**Shoreland Permit Application**for a **Shoreland Protection Permit** under  
Chapter 49A of Title 10, § 1441 *et seq.***For Shoreland Permitting Use Only**

Application Number: 268

Reference: **Richey Camp Addition, Danville, Vermont**

**From:** David Frothingham <David.Frothingham@dirtsteel.com>  
**Sent:** Thursday, March 31, 2016 11:52 AM  
**To:** Mitchell, Mark  
**Subject:** RE: Shoreland Permit Application #268, Richey  
**Attachments:** Shore land permit revised pages 2 & 3.pdf; C1.01 SITE PLAN r3-31-16.pdf

REVISION	
		NO.	DATE
1	03/31/16	ADDED TREE PLANTINGS ALONG STREAM BANK	
<b>OFFICE ADDITION</b> 422 NORTH SHORE ROAD DANVILLE, VERMONT CHRIS BISSELL			
SHEET DESCRIPTION			
PROJECT NO.		DATE	
16027		9 MAR 2016	
SCALE		1"=5'	
DRAWN		C1.01	
RBC			
CHECKED		SHEET	
DLF		SHEET 2 OF 2

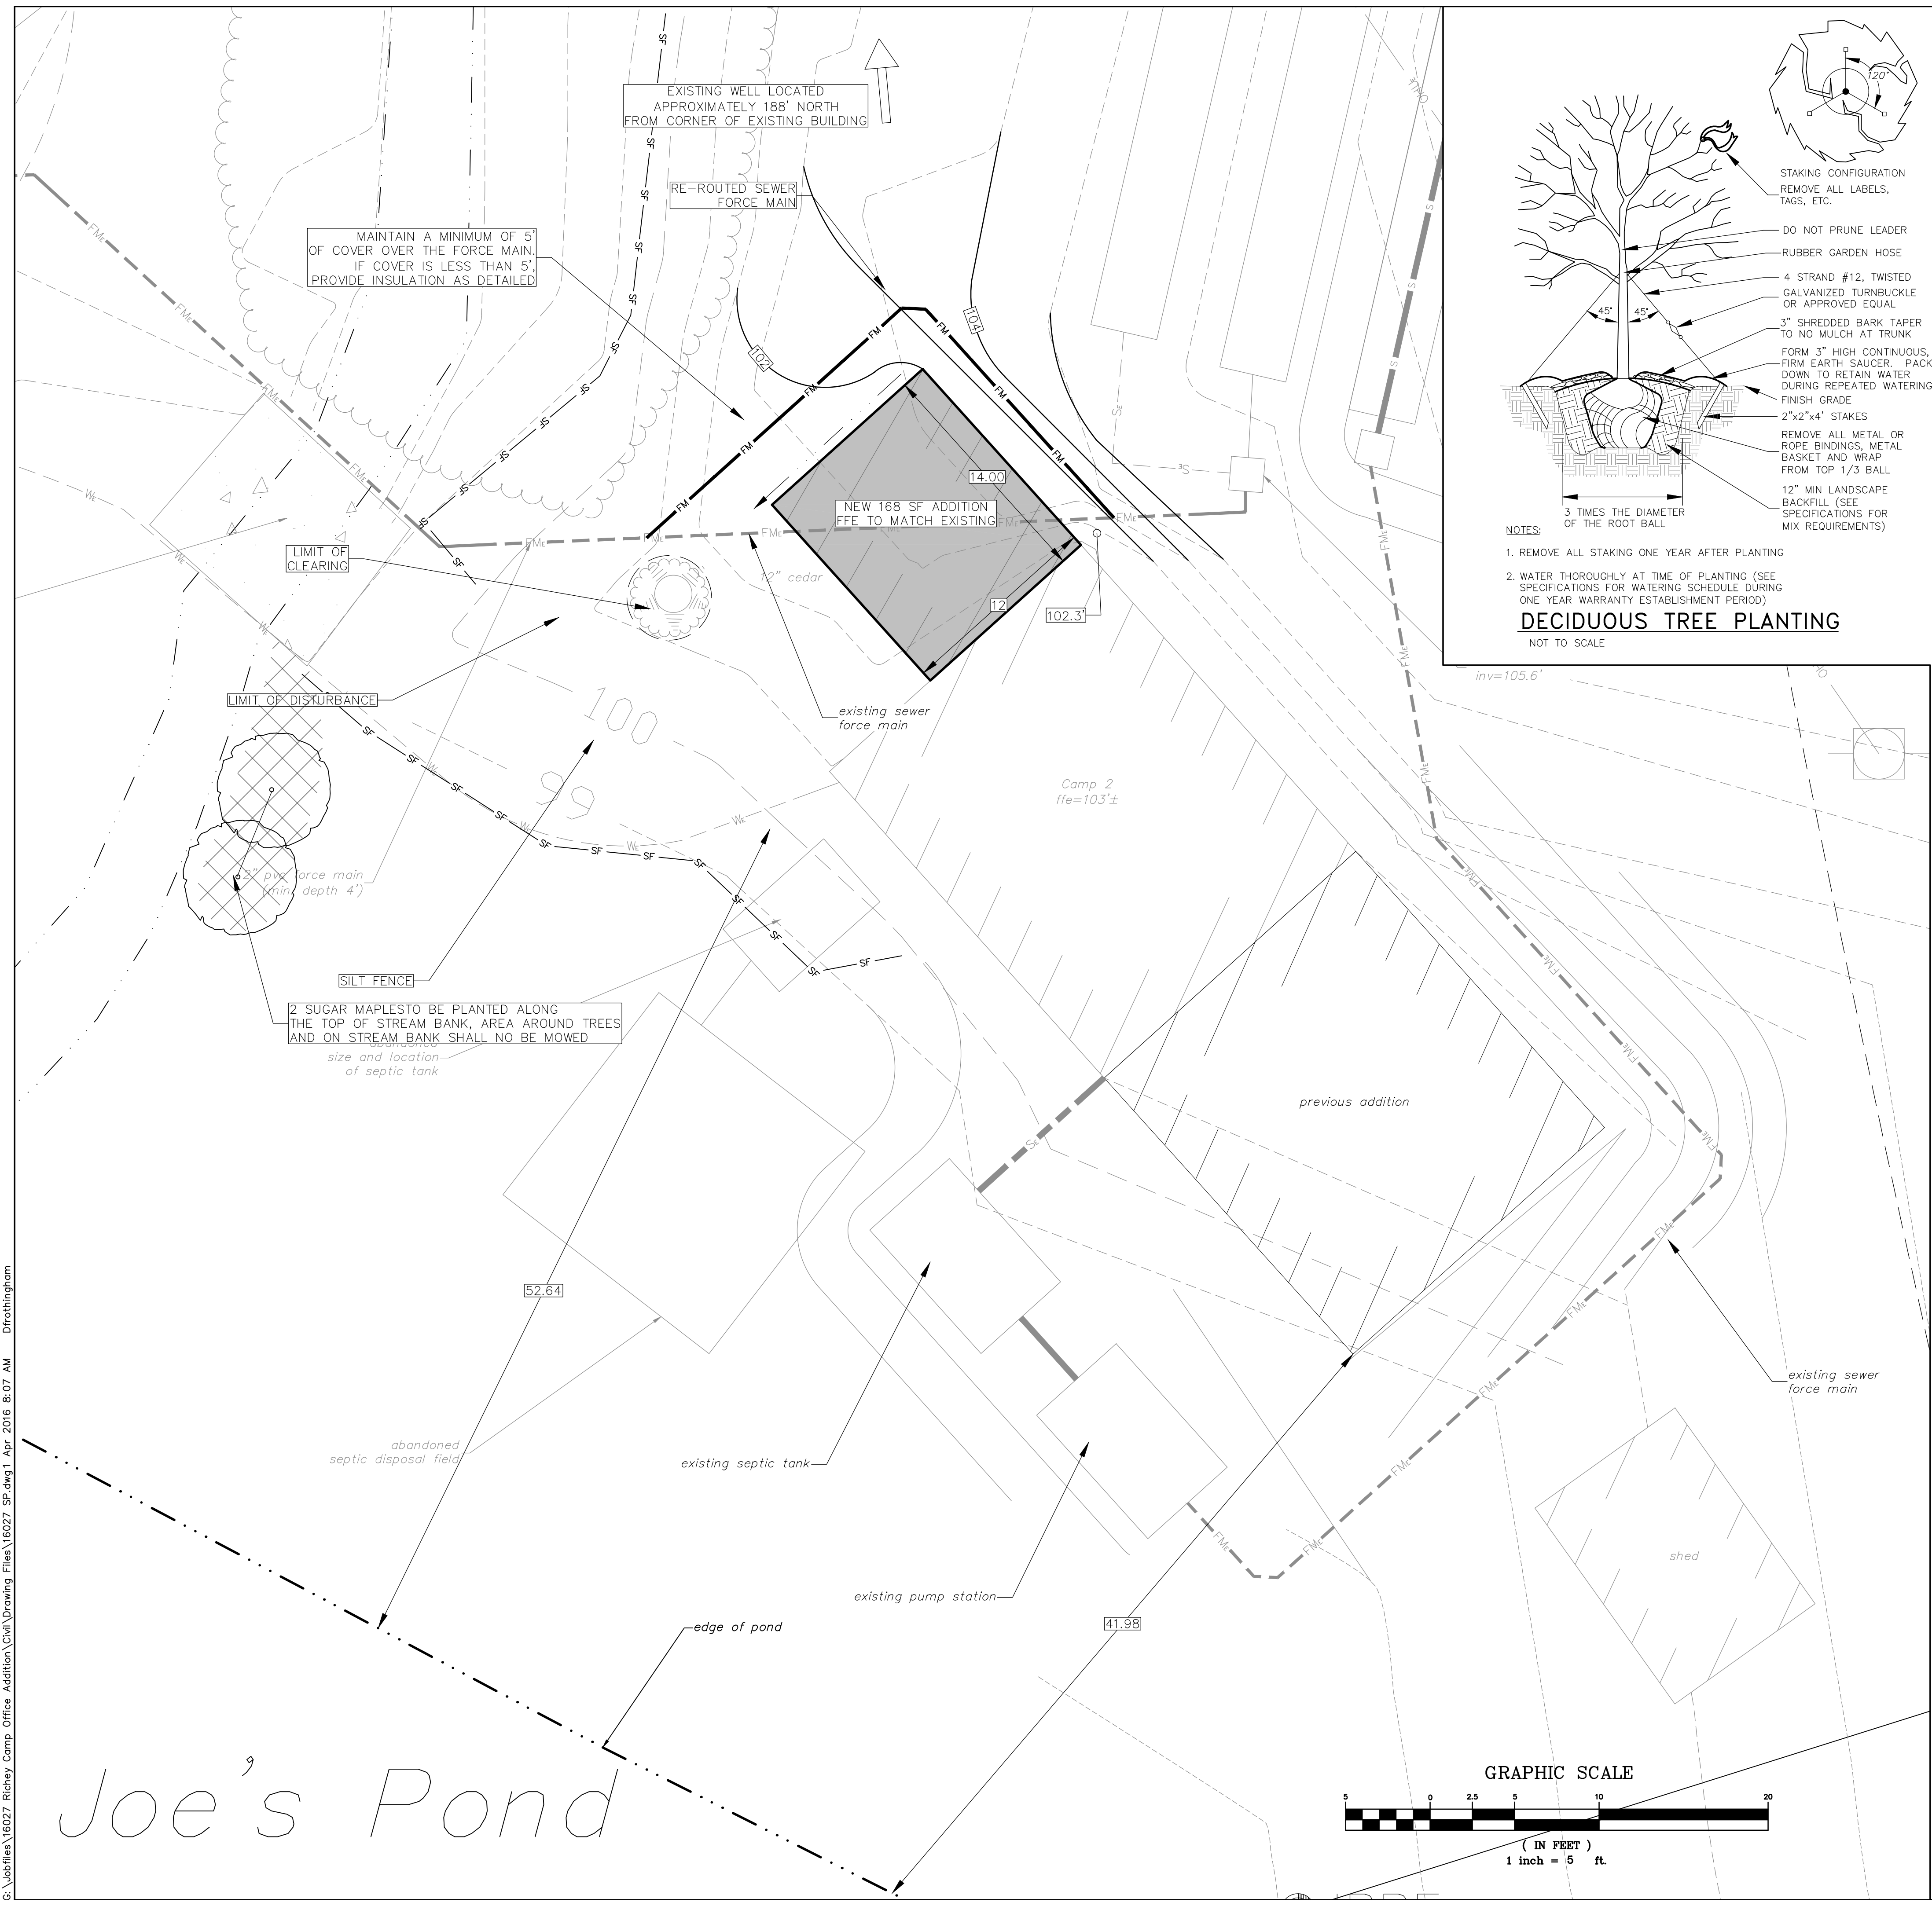
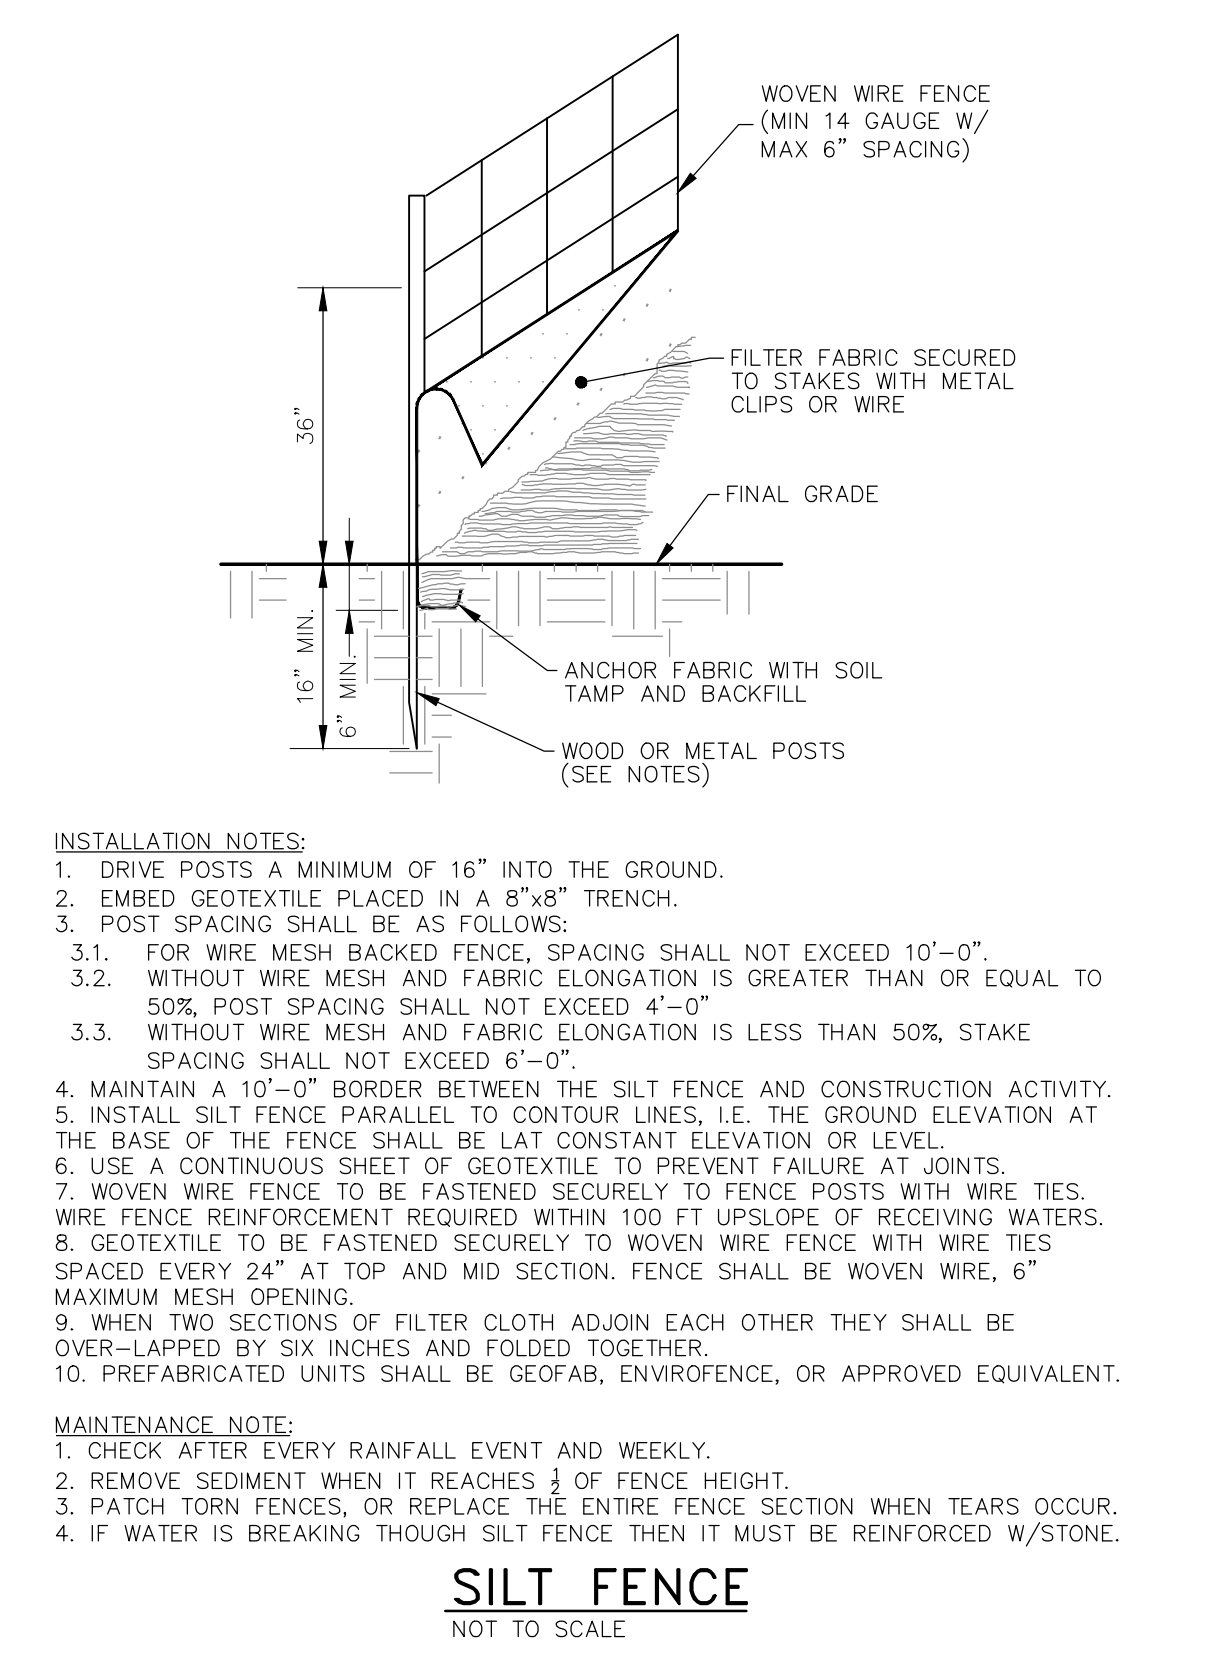
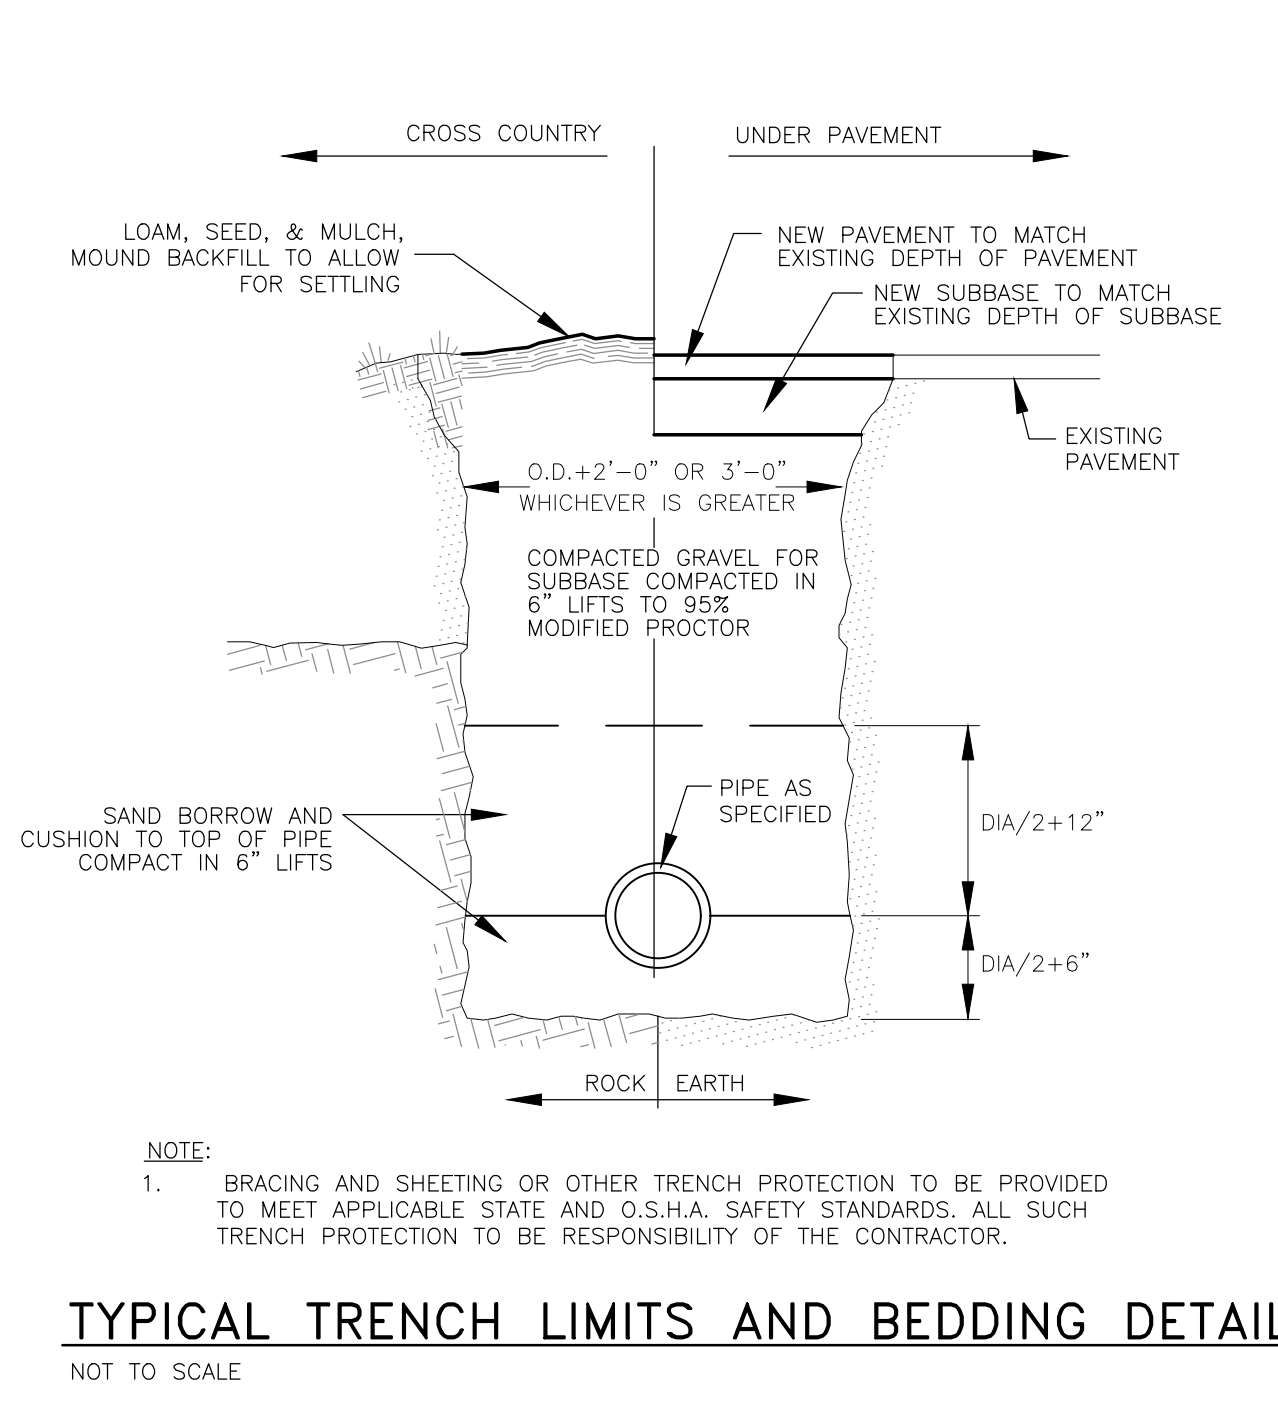
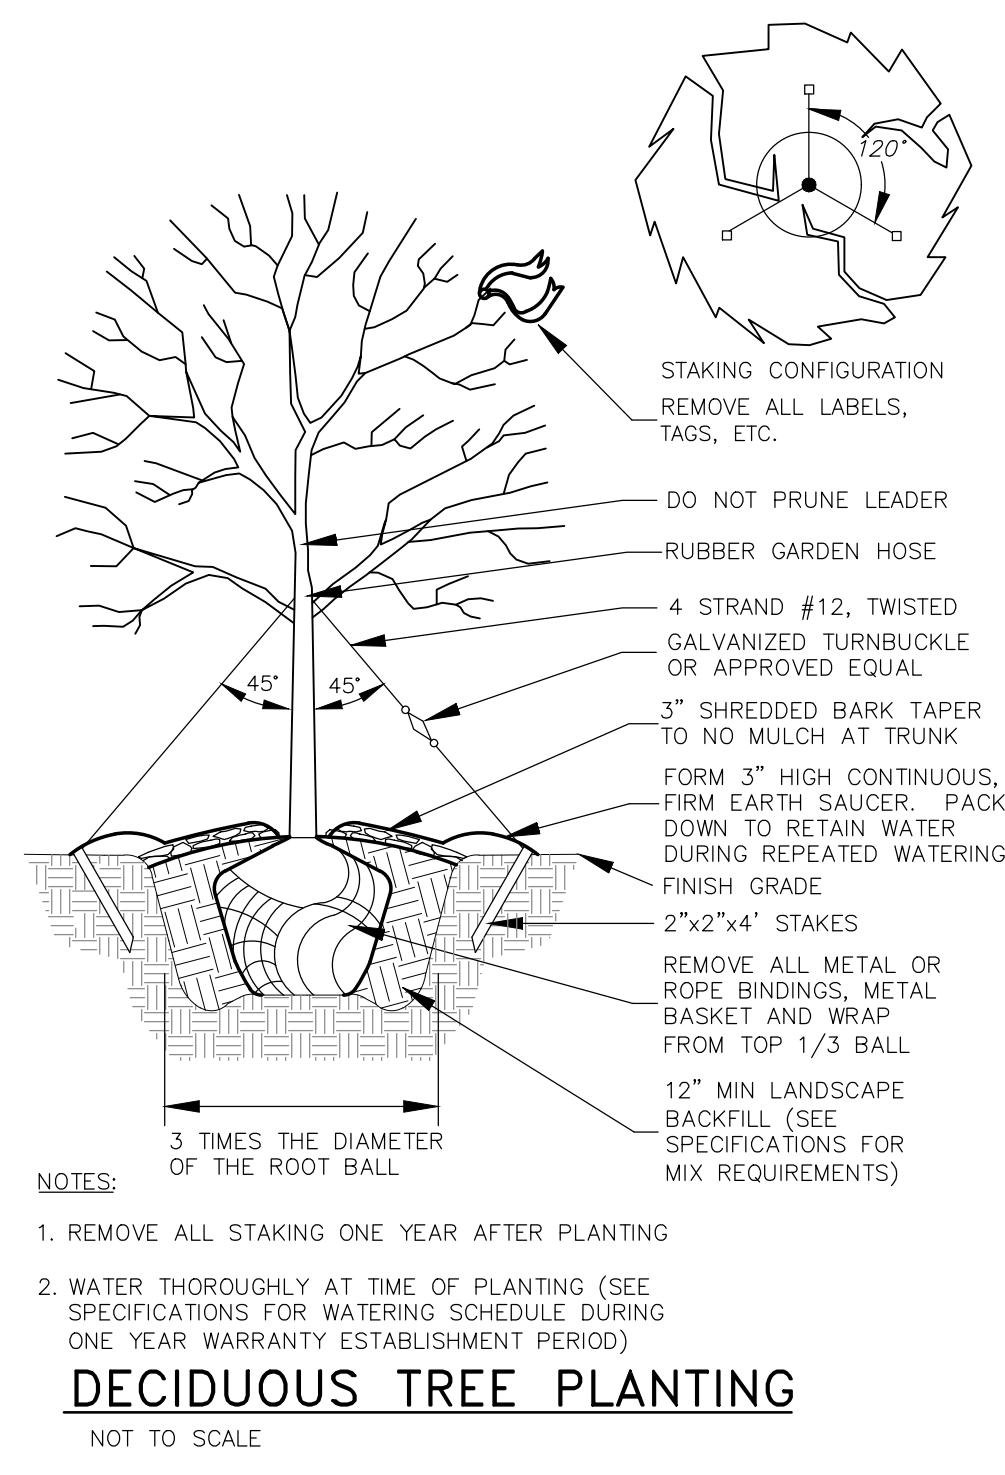
- 1) Section D.1 states that the new impervious area created will total 280 SF, but Section 5a states it will be 168 SF.
- 2) Section D.1 also states that the total cleared area on the property would be increased by 350 SF, but Section 6a states it will be 40 SF.
- 3) Section 6c must address the new cleared area through revegetation of an equal surface area within the same distance from mean water level.

Please find attached the revised site plan and application pages. The applicate proposes to plant two maple trees along the top of bank of the adjacent stream. These trees will provide shade for the stream and the canopies, when grown, will exceed the 40sf required.
